Docket No. STN 52-001

Subject: Submittal Supporting Accelerated ABWR Review Schedule - DFSE  
**Chapter 7 Outstanding Item**

## CLOSURE OF ABWR Draft FSER OPEN AND CONFIRMATORY ITEMS

Figure 7.2-9b REACTOR PROTECTION SYSTEM IED -- SHEET 2

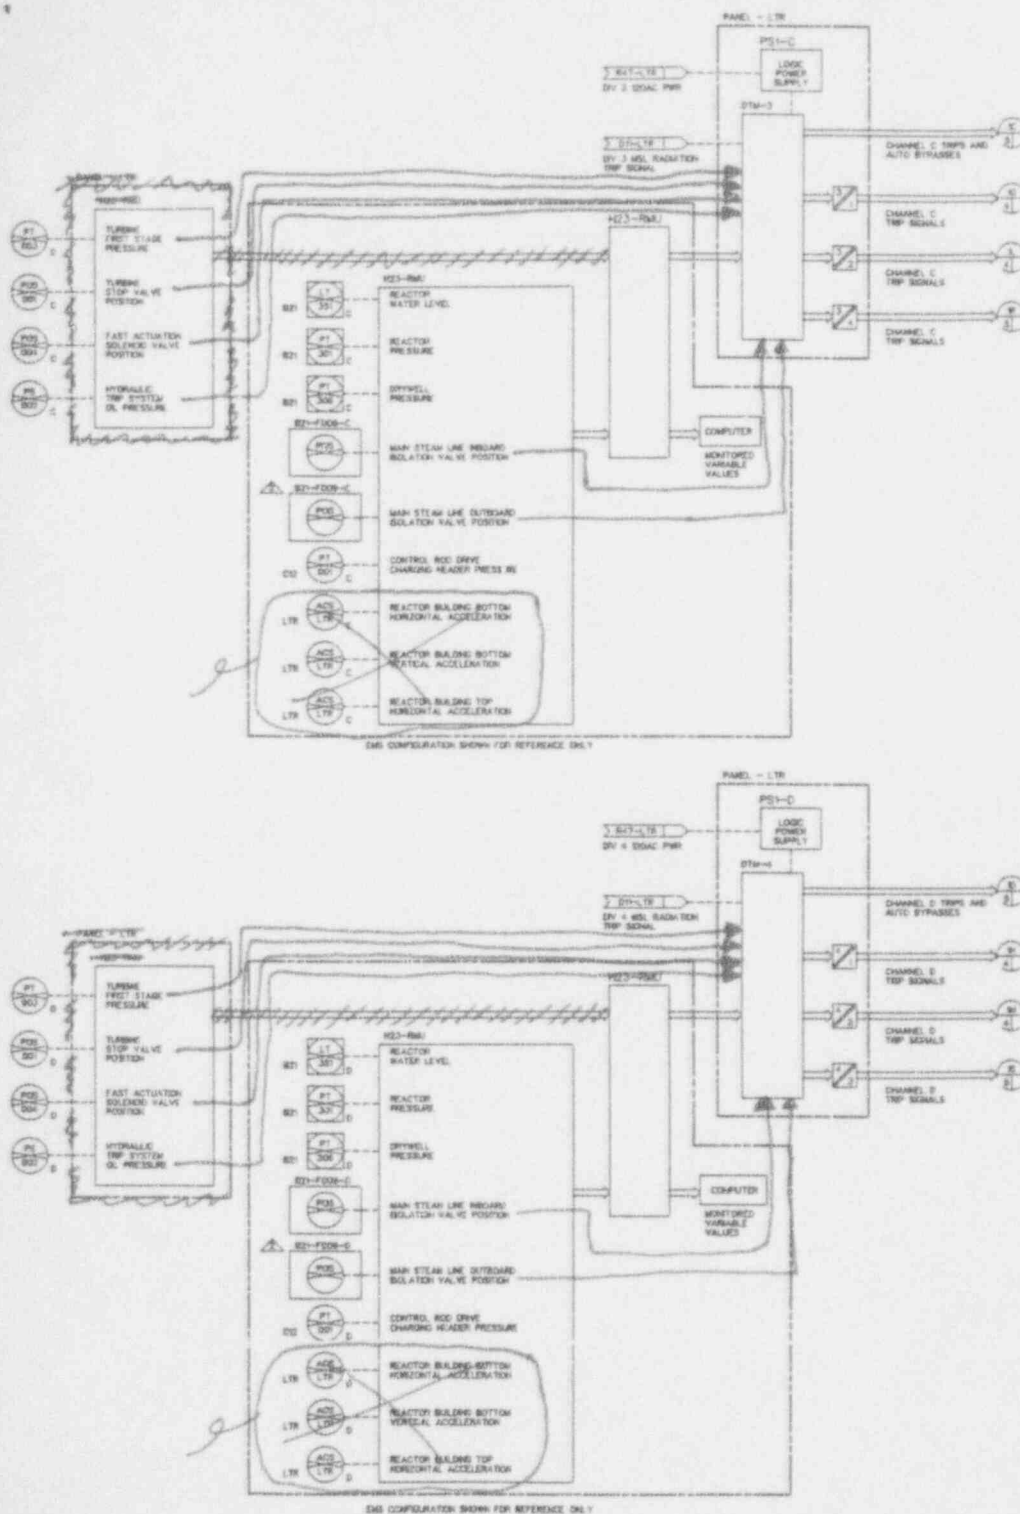
Revise SSAR text and figures to indicate that turbine inputs to SSLC are not multiplexed.

- a. SSAR Section 7.2 revised (see attachment).
- b. Marked-up figures are attached: Figures 7.2-2, 7.2-9a, 7.2-9b. Additional changes shown are hardwired MSIV position switches and deletion of seismic acceleration sensors (not applicable to domestic ABWR design).

except those  
from the  
Turbine  
Building  
manipulated  
and MSIV  
position  
switches

Figure 7A.2-1 SAFETY SYSTEM LOGIC AND CONTROL (SSLC)

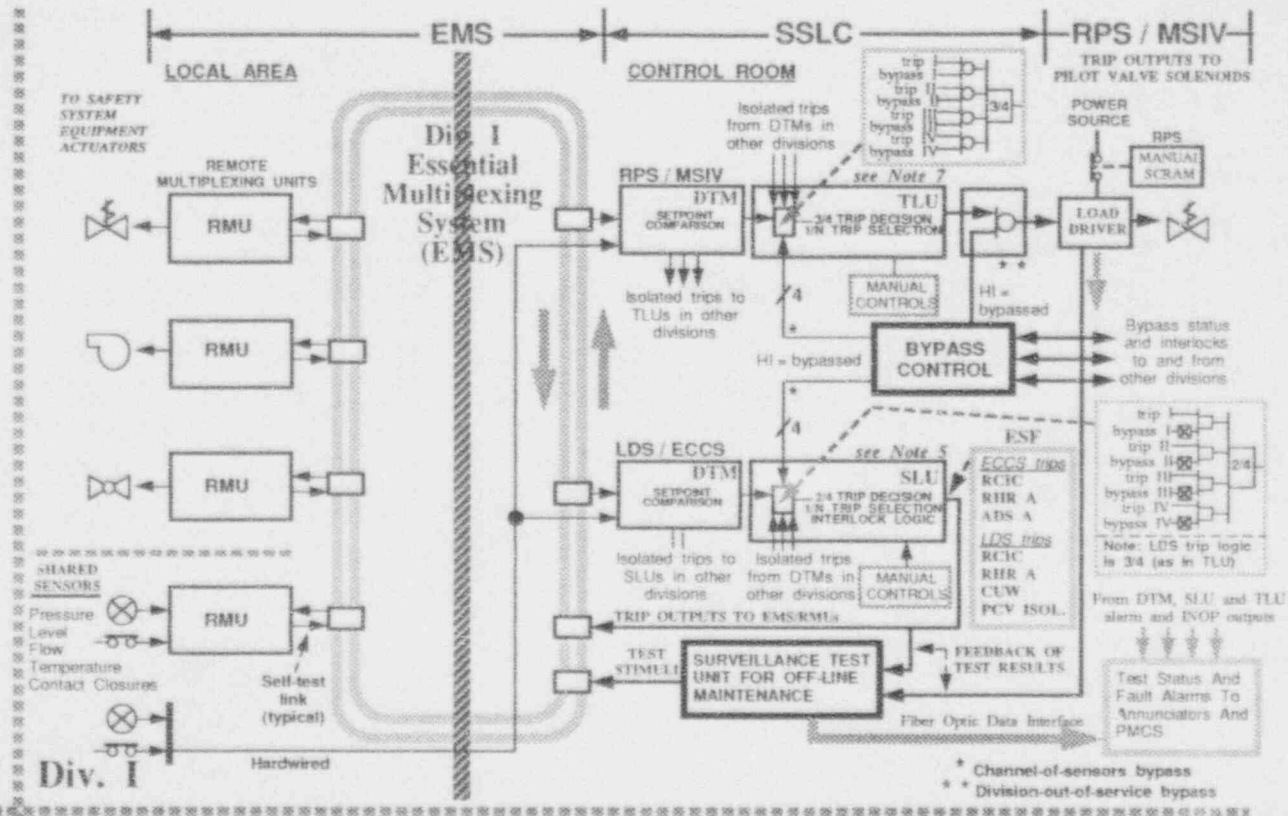
- a. Revise Figure 7.A.2-1 in Appendix 7A to show direct hardwired inputs into DTM.
- b. Revise SSAR to reflect accurate listing of sensors that use EMS.

- a. Revised Figure 7.A.2-1 is attached, showing hardwired inputs.
- b. Revised listing of EMS sensors (April 1993) is attached.
